OIL CONSERVATION DIVISION

WELL API NO. <u>301015-00572</u>
Indicate Type of Lease STATE <input checked="" type="checkbox"/> FEE <input type="checkbox"/>
State Oil & Gas Lease No.
Lease Name or Unit Agreement Name Hitchcock - 27
Well No. 2
Pool name or Wildcat Dog CanyonD

SUNDRY NOTICES AND REPORTS ON WELLS

Operator Marcel Emma Corp
 Well Hitchcock 27
 Unit D Section 27 Township 16 Range 27
 API # 30-015--00572

TOPS

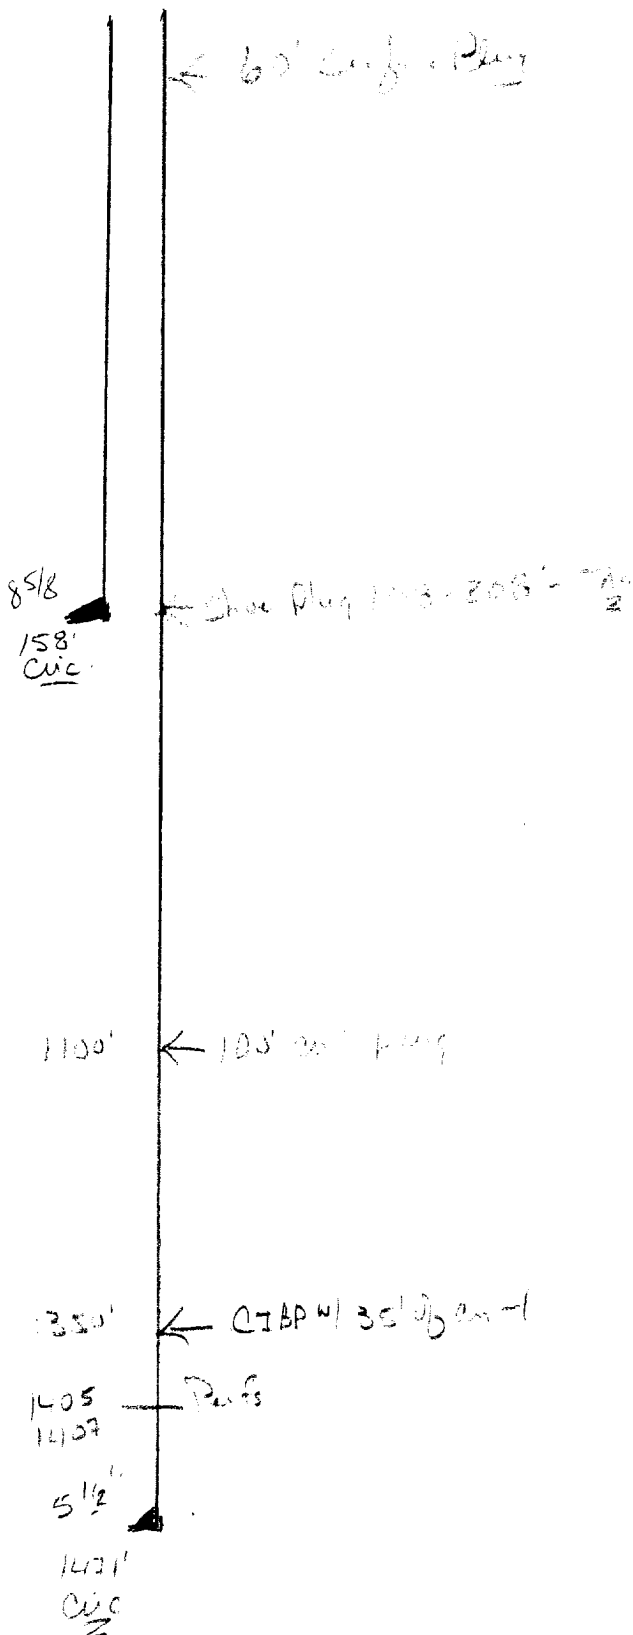
- Contact OCD 24 hrs. prior to any work done.
- Salt gel mud consisting of 10# brine with 25# of gel per barrel must be placed between each plug
- Install dry hole marker as per rule 202.B.2
- Plugs are to be set from point indicated up. Plugs must not be less than 100' or 25 Sacks of cement, whichever is greater, unless specifically indicated.
- Shoe and stub plugs will be 50' above and below shoe or stub and tagged.
- Surface plug will be from 0' - 60'
- Where plugs are required cement must be placed inside and outside of all casing string(s), in the correct footage or sacks required, if no cement exists.
- Plugs to be tagged will be indicated.

★ This would be the suggested P&T. Borrow from the state, however the BLM must approve the P&T procedure.
